**ZONING AMENDMENT,  
PLANNED UNIT DEVELOPMENT &  
SUBDIVISION STAFF REPORT**

**Date: August 2, 2012**

<b><u>NAME</u></b>	Michael A. Rost
<b><u>SUBDIVISION NAME</u></b>	Broad Palmetto Subdivision
<b><u>LOCATION</u></b>	202 South Broad Street (West side of South Broad Street, 55'± South of Palmetto Street and extending West to the South side of Palmetto Street, 130'± West of South Broad Street).
<b><u>CITY COUNCIL DISTRICT</u></b>	District 2
<b><u>PRESENT ZONING</u></b>	R-1, Single-Family Residential District
<b><u>PROPOSED ZONING</u></b>	R-1, Single-Family Residential District and R-B, Residential-Business District
<b><u>REASON FOR REZONING</u></b>	None provided
<b><u>AREA OF PROPERTY</u></b>	0.4 Acres ±
<b><u>CONTEMPLATED USE</u></b>	Subdivision approval to create 2 legal lots of record from one legal lot of record and two metes and bounds parcels; Planned Unit Development Approval to allow reduced lot size and reduced setbacks, to allow renovation of an existing dwelling for office use as well as construction of a new single family dwelling on a proposed substandard lot; and Rezoning from R-1, Single-Family Residential District, to R-B, Residential-Business District to allow th

# SITE PLAN

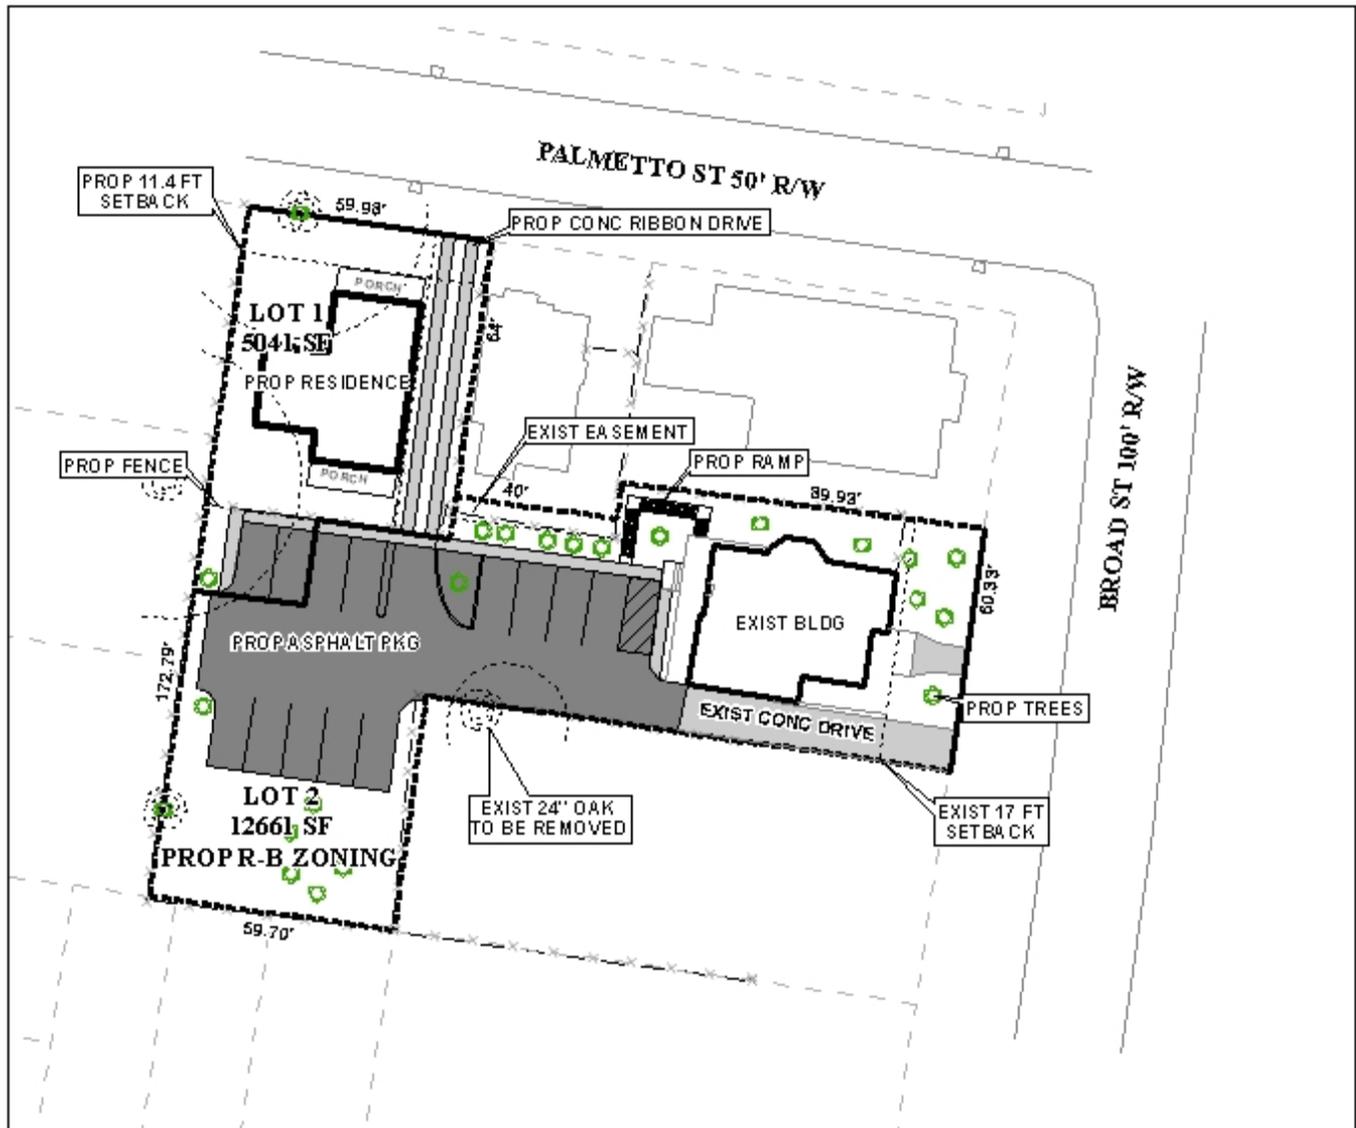
The lot area sizes are depicted on the plat in square feet and acres, and this should be retained on the Final Plat, if approved. The applicant proposes to have a front setback on Lot 1 of 11.4’, which is the same setback depicted for the adjacent property to the East of Lot 1. The applicant also illustrates the existing 17’ front setback for Lot 2, which is a greater setback than the property adjacent to the North, which has a setback of 10’ ±. Section 64-3.G. 3. of the Zoning Ordinance makes a provision for properties within recognized historic districts, allowing them to have reduced setbacks from what would otherwise be required, this would make a waiver of Section V.D.9. of the Subdivision appropriate, and the illustrated proposed front setbacks in keeping with the area.

If the proposed Lot 2 is rezoned, as requested, that the applicant will be required to provide a protection buffer of 10' as well as either a 6' high privacy fence or 10' wide screen planting strip no less than 6' in height at time of planting and consisting of evergreen vegetation alongside all adjacent R-1, Single-Family Residential properties. The site plan illustrates existing and proposed fencing along residential properties; however no mention is made of the height or material of the fence. Also, the existing structure proposed to be an office sits 8' ± from the property to the right; therefore the site is unable to provide the required 10' protection buffer. The previous plans also did not make note of the height and type of existing fence, nor did it illustrate a proposed fence on the proposed dwelling on Lot 1.

It should be noted that the landscape plan submitted does not provide the species of trees to be planted, accurate tree planting calculations, or landscaped area information. However, the site plan does appear to illustrate compliance with the number of required tree plantings and total landscaped area, while it appears there is a deficit in the required amount of frontage landscaping, with approximately 750 square feet of frontage landscaped illustrated and 912 square feet of frontage landscaping required. Despite this, a PUD does allow some flexibility concerning the amount of landscaping and tree planting requests

Furthermore, there is no depiction of a dumpster or note provided to determine if the applicant will comply with Section 64-4.D.9. of the Zoning Ordinance.

The applicant depicts an existing 10.5' curb-cut and a driveway that ranges from 10.5' to 11.9' for Lot 2, which is considerably less than the minimum 24' width required for two-way traffic, and is slightly less than what would typically be accepted for one-way traffic, and was of major concern with the last applications for this site. The applicant has revised the site plan to include a 14' wide ingress, egress, and utility easement with the proposed Lot 1 of the subdivision. According to Traffic Engineering comments, if approved, one-way (in-bound) signage should be placed at the Broad Street curb-cut with signage directing traffic to exit at the Palmetto Street curb-cut. Because this would leave the residence of the proposed dwelling on Lot 1 with no place on site to park, the site plan has been adjusted to include 2 parking spaces that are part of the parking lot on Lot 2, to be on the property of Lot 1, thus providing parking for the dwelling. The previously denied site plan illustrated the single curb-cut on Lot 2 as the only entrance and exit to the proposed parking area. The proposed access design would result in conditions that are not in support of the primary purpose of the Zoning Ordinance as stated in Section 64-1.A, in that it may increase traffic congestion on public streets, and could result in dangerous conditions that would threaten the health and general welfare of the citizens of the City of Mobile.

The proposed 2,997 square foot the office building would require 10 parking spaces, and the site illustrates 13 parking spaces to be paved with asphalt, with three of them designated as employee only parking. Also, as mentioned previously, the applicant intends for two parking spaces to be used by the residents of the proposed dwelling on Lot 1. The previously denied site plan only illustrated 10 parking spaces which were to have gravel surfacing with the exception of a single handicapped parking space. If approved, this would place a commercial parking lot in the middle of a primarily residential block, surrounded completely by residences in a historic district which may increase traffic, light, and noise.

The site plan submitted does not depict the existing sidewalks along Broad Street and Palmetto Street. In addition, any required storm detention is not depicted on the site plan as well.

*As submitted, the site plan does not reflect discussions with staff prior to submission and cannot be recommended for approval. Staff suggested that the applicant request both proposed lots be rezoned from R-1, Single-Family Residential District to R-B, Residential-Business District. The applicant also changed the lot configuration to include two parking spaces as part of the proposed Lot 1, which staff did not recommend. Because the applicant did not follow staff recommendations and no new information has been submitted for staff review, the original recommendation for denial stands.*
